Rev.	Date	By	Ckd	Description
I	17/08/2023	WN	DN	S4.56 Issue 2

30 Fairlight St, Fairlight
30 Fairlight St,
Fairlight, NSW 2094

SCHEDULE OF CHANGES

DA200
I

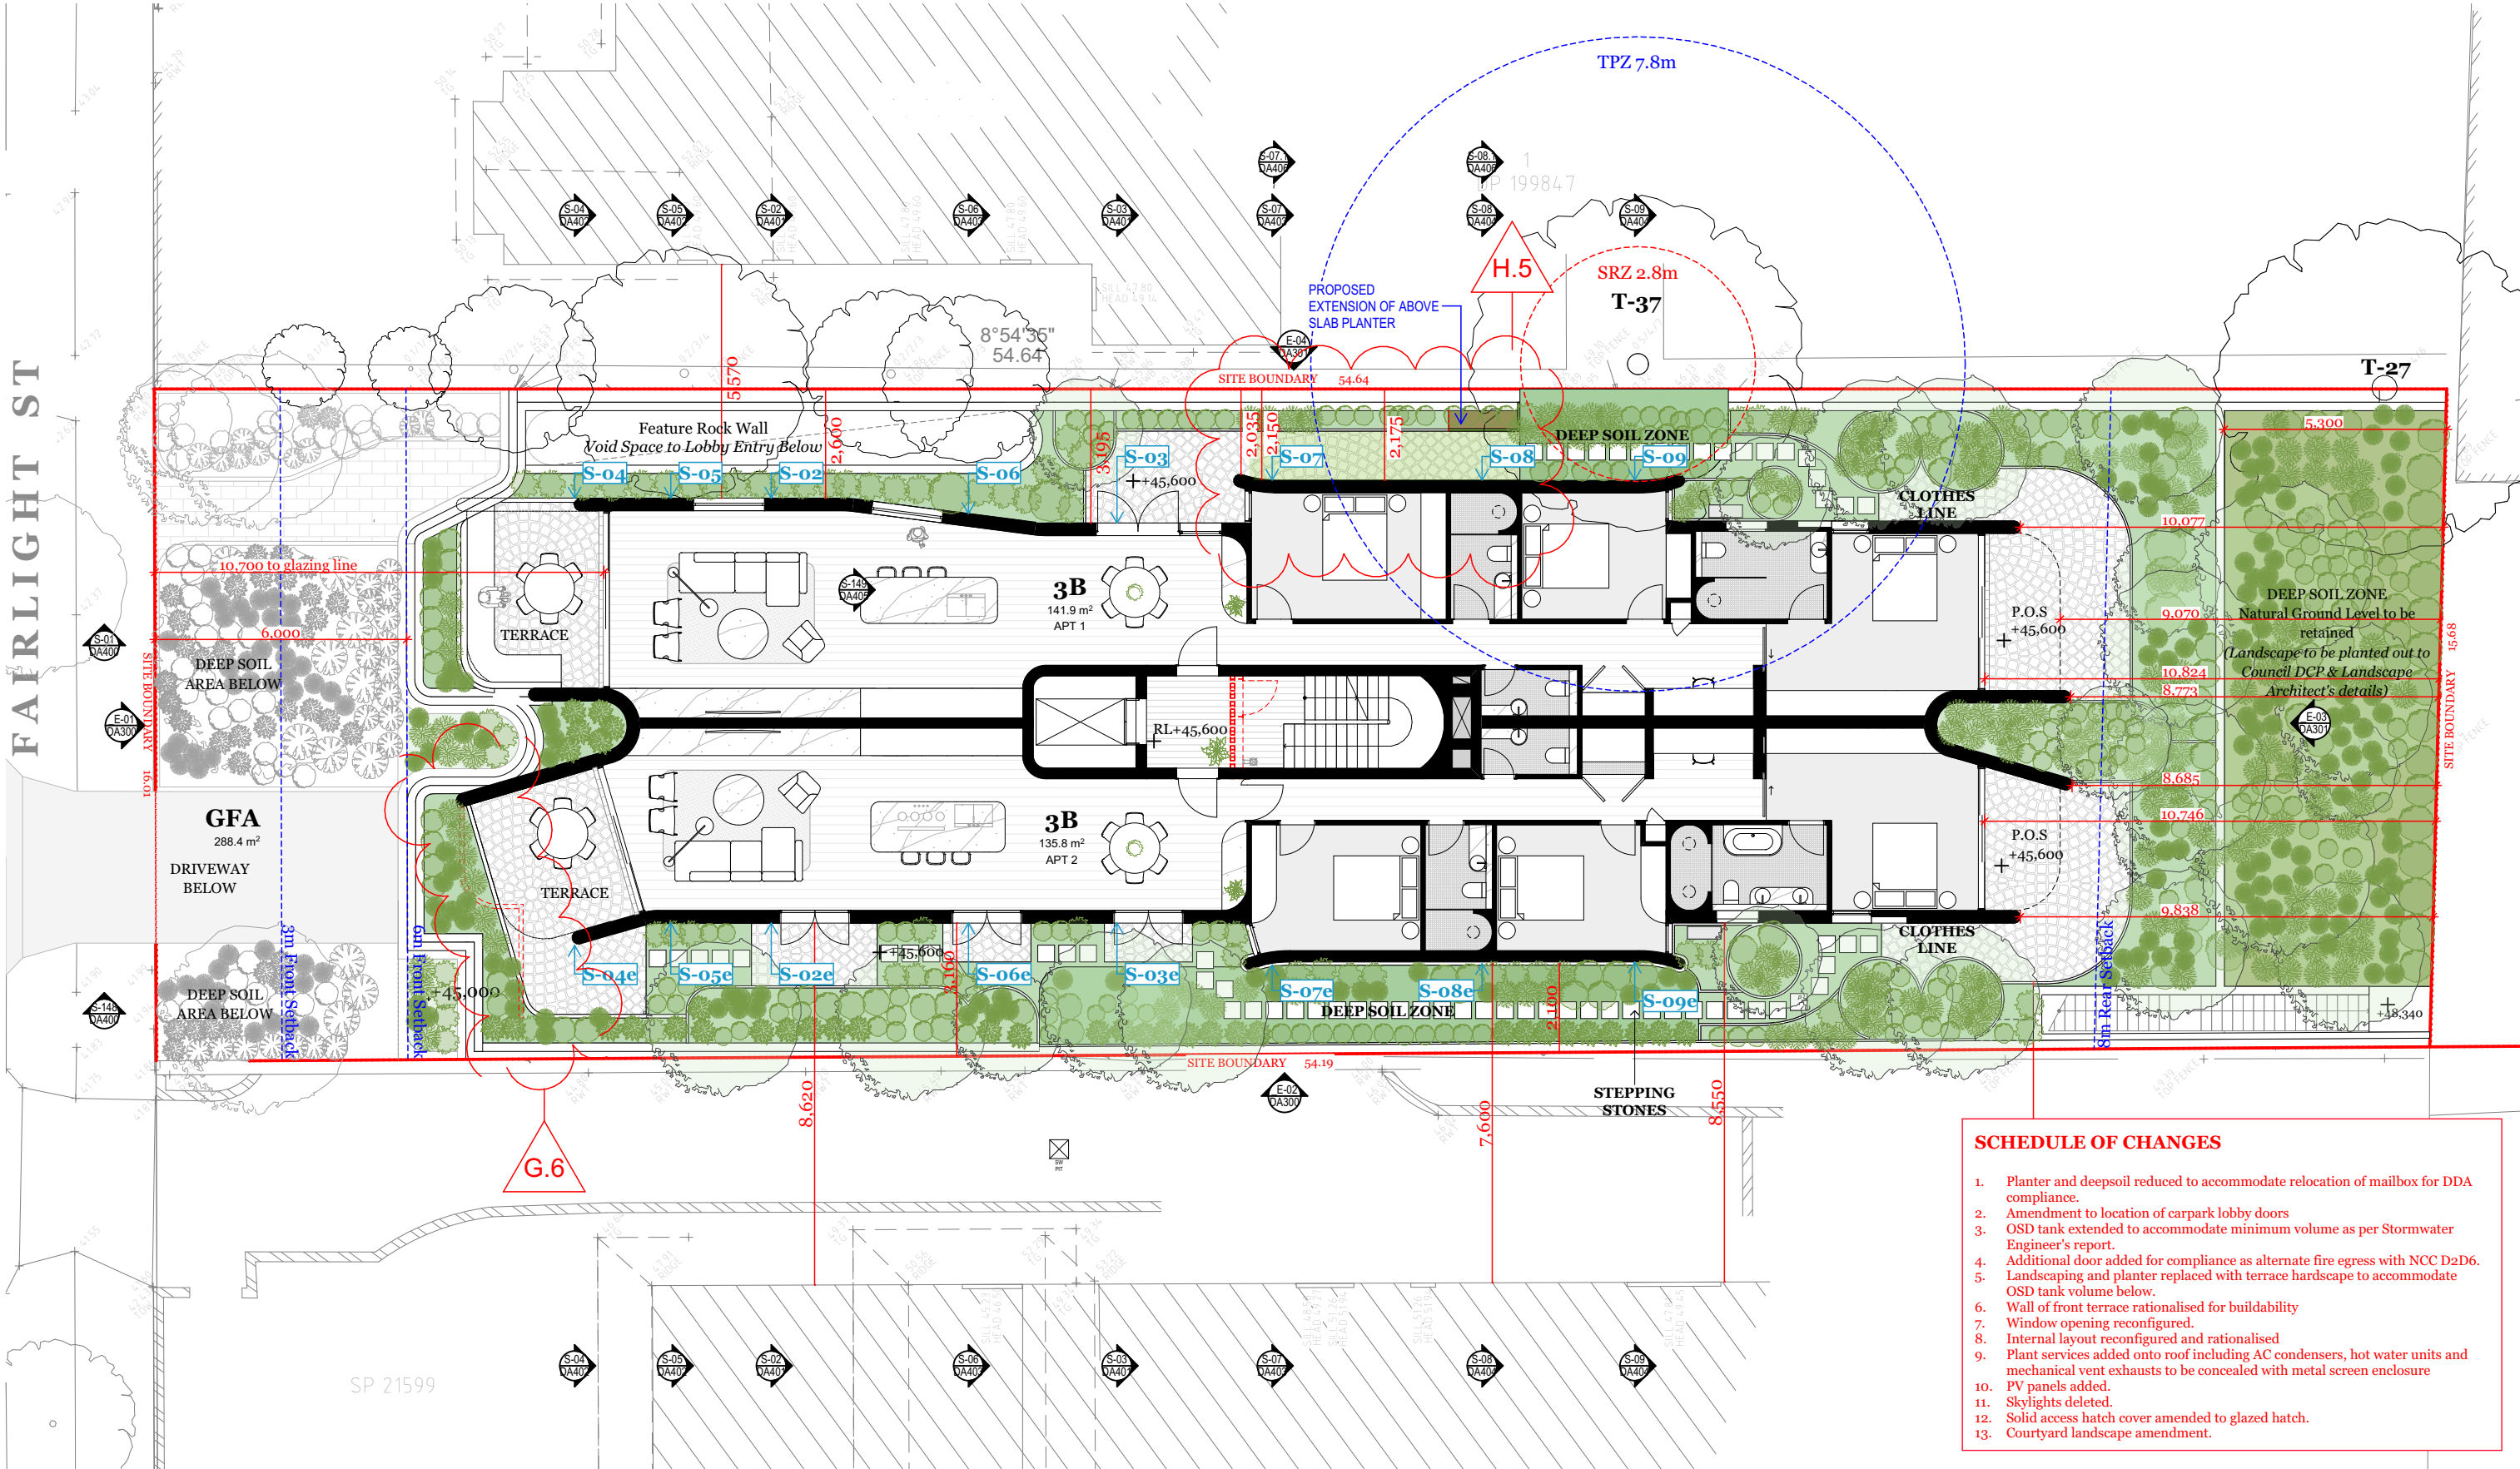
1. Planter and deepsoil reduced to accommodate relocation of mailbox for DDA compliance.
2. Amendment to location of carpark lobby doors
3. OSD tank extended to accommodate minimum volume as per Stormwater Engineer's report.
4. Additional door added for compliance as alternate fire egress with NCC D2D6.
5. Landscaping and planter replaced with terrace hardscape to accommodate OSD tank volume below.
6. Wall of front terrace rationalised for buildability
7. Window opening reconfigured.
8. Internal layout reconfigured and rationalised
9. Plant services added onto roof including AC condensers, hot water units and mechanical vent exhausts to be concealed with metal screen enclosure
10. PV panels added.
11. Skylights deleted.
12. Solid access hatch cover amended to glazed hatch.
13. Courtyard landscape amendment.

Drawing Number **DA203**
Revision **G**

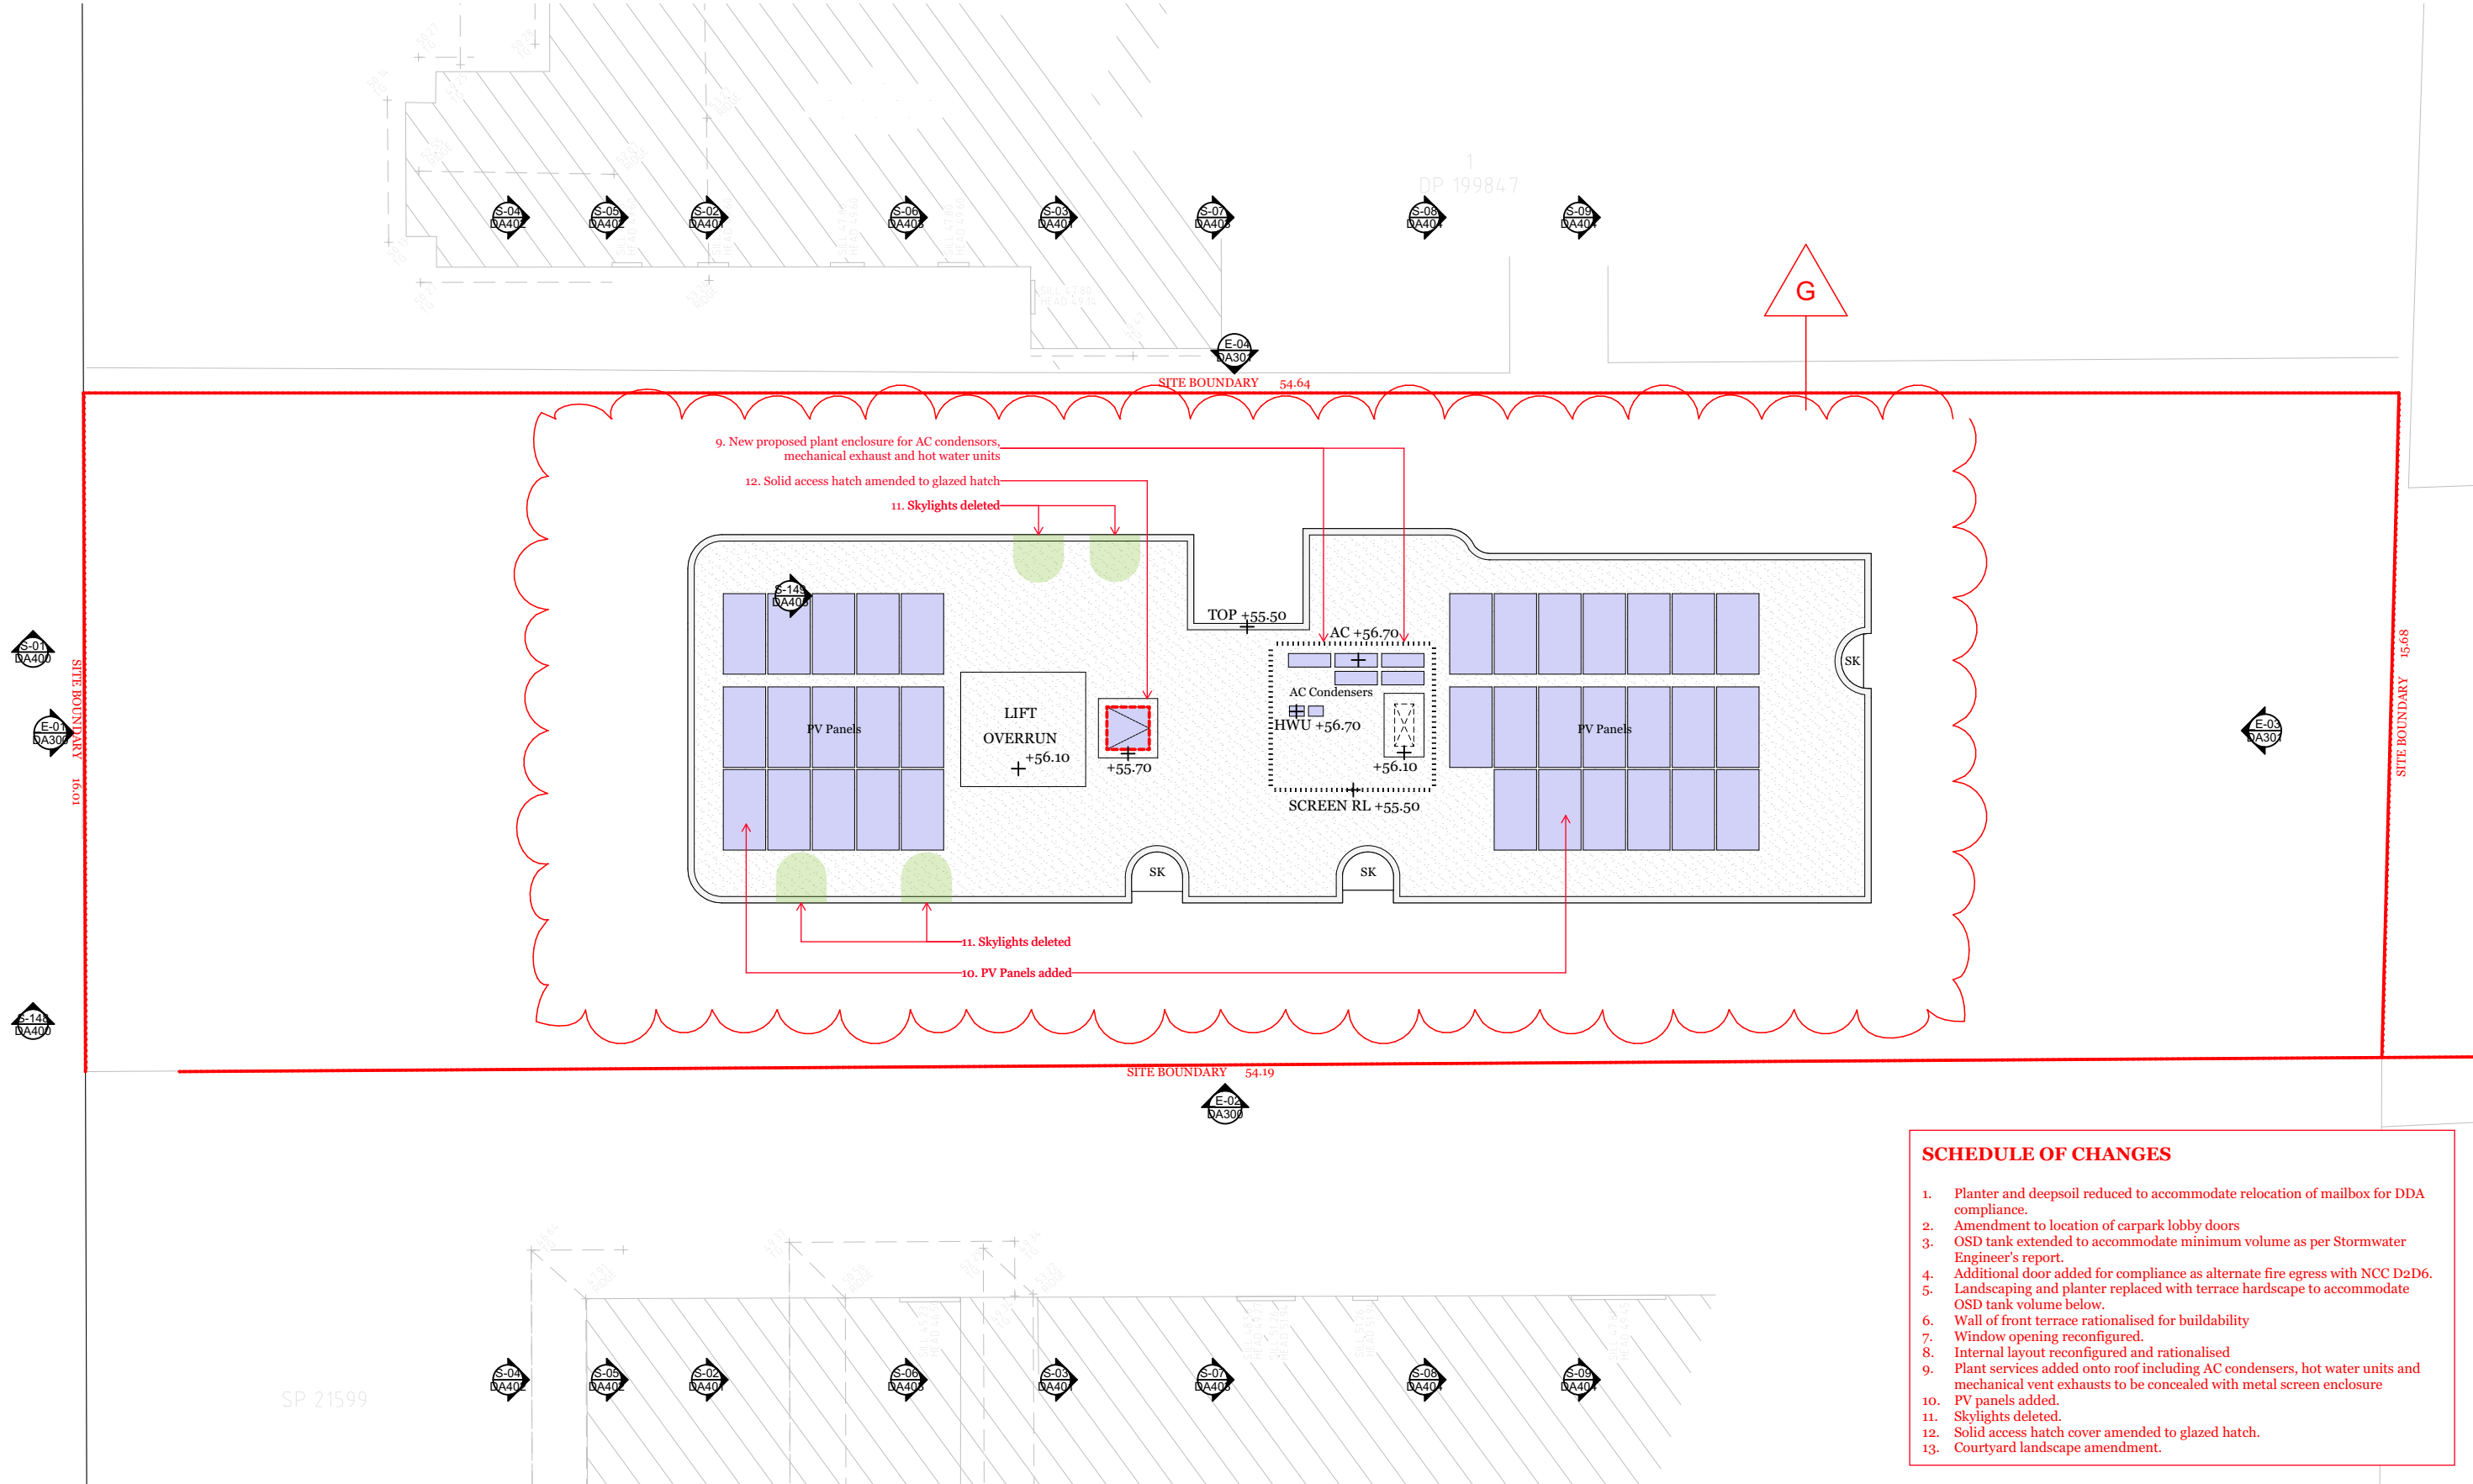
1. Planter and deepsoil reduced to accommodate relocation of mailbox for DDA compliance.
2. Amendment to location of carpark lobby doors
3. OSD tank extended to accommodate minimum volume as per Stormwater Engineer's report.
4. Additional door added for compliance as alternate fire egress with NCC D2D6.
5. Landscaping and planter replaced with terrace hardscape to accommodate OSD tank volume below.
6. Wall of front terrace rationalised for buildability
7. Window opening reconfigured.
8. Internal layout reconfigured and rationalised
9. Plant services added onto roof including AC condensers, hot water units and mechanical vent exhausts to be concealed with metal screen enclosure
10. PV panels added.
11. Skylights deleted.
12. Solid access hatch cover amended to glazed hatch.
13. Courtyard landscape amendment.

DA300
H

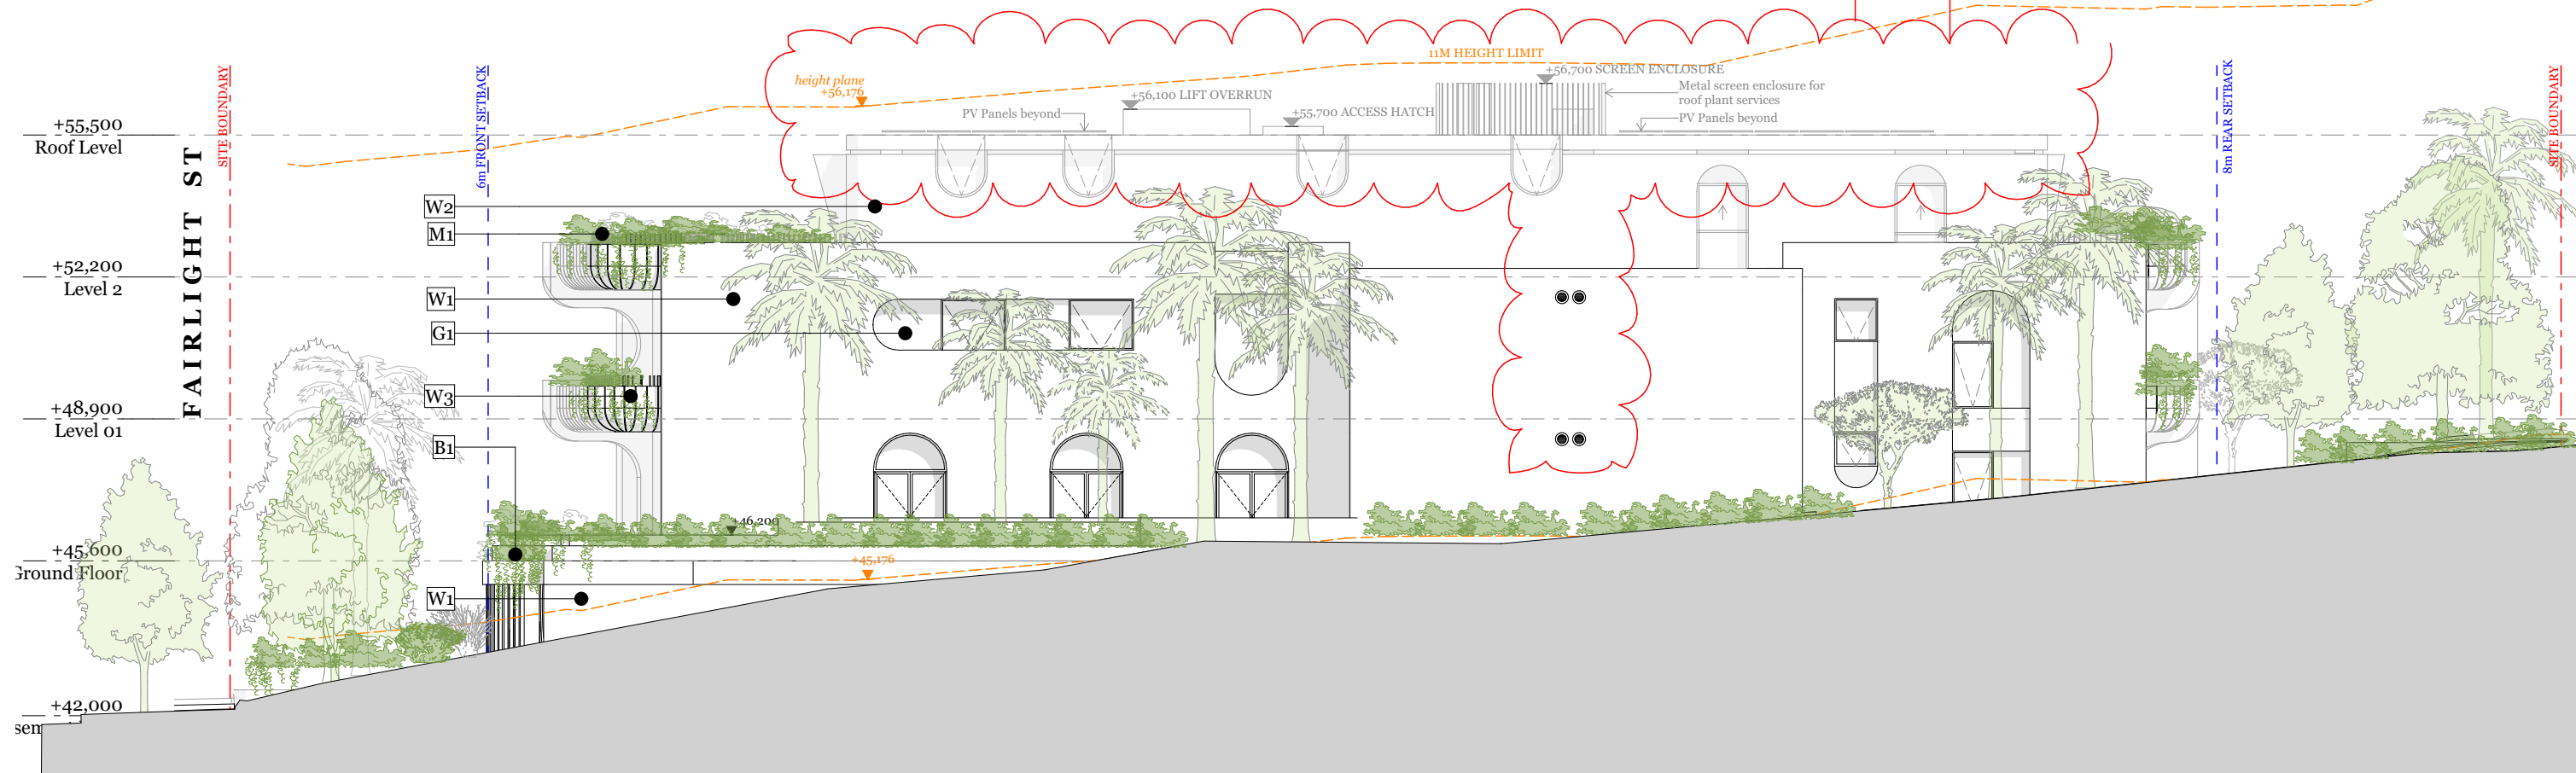
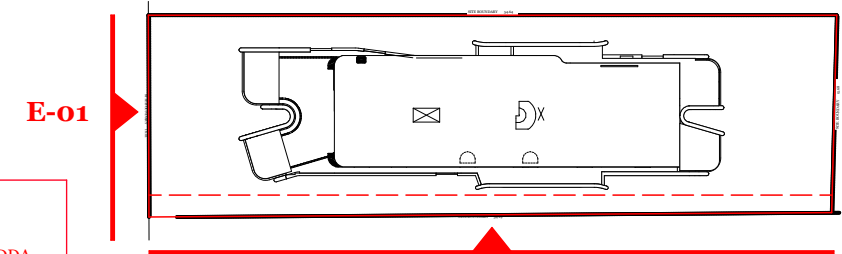
1. Planter and deepsoil reduced to accommodate relocation of mailbox for DDA compliance.
2. Amendment to location of carpark lobby doors
3. OSD tank extended to accommodate minimum volume as per Stormwater Engineer's report.
4. Additional door added for compliance as alternate fire egress with NCC D2D6.
5. Landscaping and planter replaced with terrace hardscape to accommodate OSD tank volume below.
6. Wall of front terrace rationalised for buildability
7. Window opening reconfigured.
8. Internal layout reconfigured and rationalised
9. Plant services added onto roof including AC condensers, hot water units and mechanical vent exhausts to be concealed with metal screen enclosure
10. PV panels added.
11. Skylights deleted.
12. Solid access hatch cover amended to glazed hatch.
13. Courtyard landscape amendment.
